■ □ □ ■ **E. Walls (Interior and Exterior)**

Figure 11

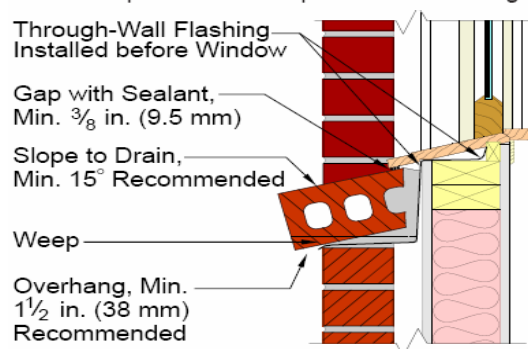
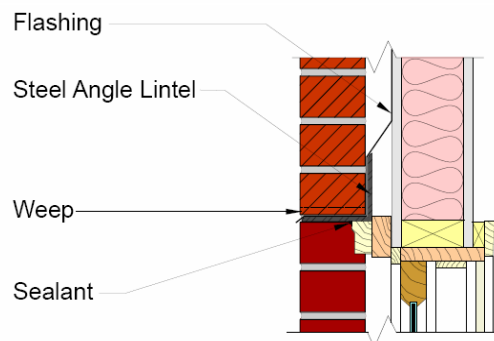
The brick window ledgers were improperly or inadequately sloped at most of the window penetrations (see figure 11 above). Proper industry installation requirements are that the ledgers slope a minimum of 15 degrees away from the house to allow the ledgers to drain completely. Some of the ledgers installed on the house actually sloped toward the house which will force water into the wall cavities. The ledgers should be removed and adequately sloped, at a minimum, new ledgers should be installed.

Figure 14

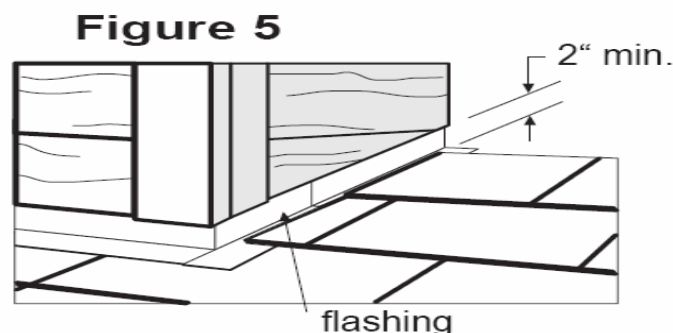
The window frames, door frames and other wall penetrations installed in the brick veneer were not properly flashed or drained. The current building code along with the 2000 and 2003 Editions of the International Residential Code, require the installation of through wall flashing above the window and door frames and below the window sill. The through wall flashing should extend from behind the wall sheathing and should terminate on the exterior of the veneer. Weep holes, for drainage of the wall cavity at the window frames, are required to be formed in the veneer above the window frames and below the sills. While weep holes had been formed in the veneer above the window and door frames, the lintels were used as the flashing. Lintels are structural support members for the veneer and are not intended for use as drains. For further information, see Sections R703.7.5, R703.7.6 and R703.8 of the IRC (International Residential Code) along with the referenced drawings in the code. For further information, go to bia.org on the World Wide Web, which is the website of the brick manufacturer's association. You can also go to the

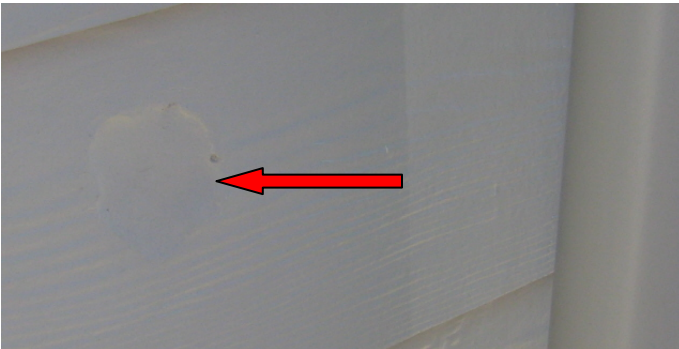
Mildew was noted on the exterior brick veneer indicating water penetration in the brick veneer. The sources of the water penetration should be determined and eliminated. Drains, such as weep holes should be installed or cleared so that the wall cavities can drain properly.

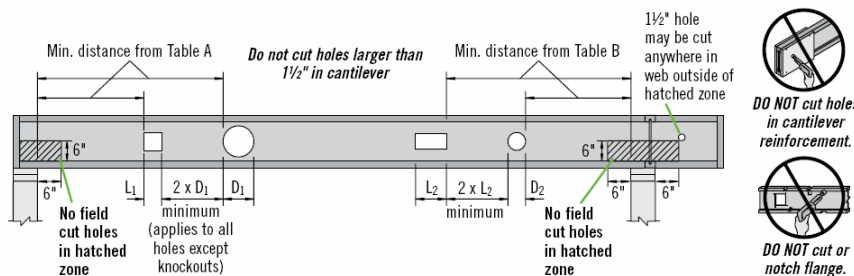
The engineered silent flooring joists were improperly bored in the garage. The joists should be removed and replaced with new joists installed according to the manufacturer's requirements for safety.
